# Access Compliance Report

## Public Rights-of-Way

### (Curb Ramps)

Intersection ID: 12632	Main Street: SEIGLE_AV	Cross Street: SKYLINE_VIEW_WY	Location: W
ADA ID: 7F5FE67E395D	Ramp Type: Directional1	Initial Pass/Fail: Fail	Overall Compliance: No
			Severity Score: 13.75

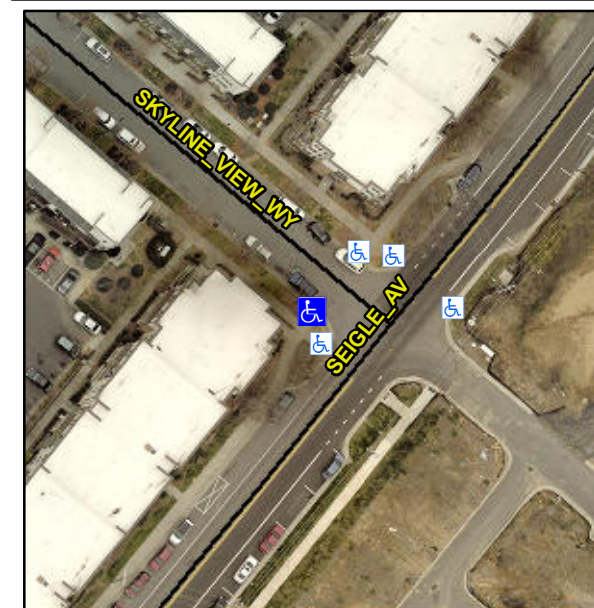
**R304.2.2, R304.5.3**

Compliance	Description	Data	Compliance	Description	Data
N/A	Ramp Length (in)	97.5	N/A	Grade Break?	N/A
Yes	Ramp Width (in)	71.5	N/A	Grade Break Slope (%)	0.0
No	Ramp Slope (%)	9.5	N/A	Grade Break XSlope (%)	0.0
No	Ramp XSlope (%)	2.1			
N/A	Flare Type LT	N/A	N/A	Flare Type RT	N/A
N/A	Flare Slope LT (%)	N/A	N/A	Flare Slope RT (%)	0.0
N/A	Flare Traversable LT?	N/A	N/A	Flare Traversable RT?	N/A
N/A	Landing Length (in)	0.0	N/A	DWS Provided?	N/A
N/A	Landing Width (in)	0.0	N/A	DWS Contrast?	N/A
N/A	Landing Slope (%)	0.0	N/A	DWS Length (in)	N/A
N/A	Landing X Slope (%)	0.0	N/A	DWS Full Width?	N/A
N/A	Landing Curb? (Y/N)	N/A	N/A	DWS Offset LT (in)	N/A
N/A	Shared Landing?	N/A	N/A	DWS Offset RT (in)	N/A
N/A	Gutter Ponding?	0.0	N/A	Gutter Slope (%)	N/A
N/A	Gutter Lip Ht (in)	0.0	N/A	Gutter X Slope (%)	N/A
N/A	Painted X Walk1?	No		Road Slope (%)	3.5
	X Walk 1 Direction	To NE		Road X Slope (%)	3.4
	X Walk 1 Width (in)	N/A		Clear Space?	N/A

**Remove & Replace Entire Ramp.**
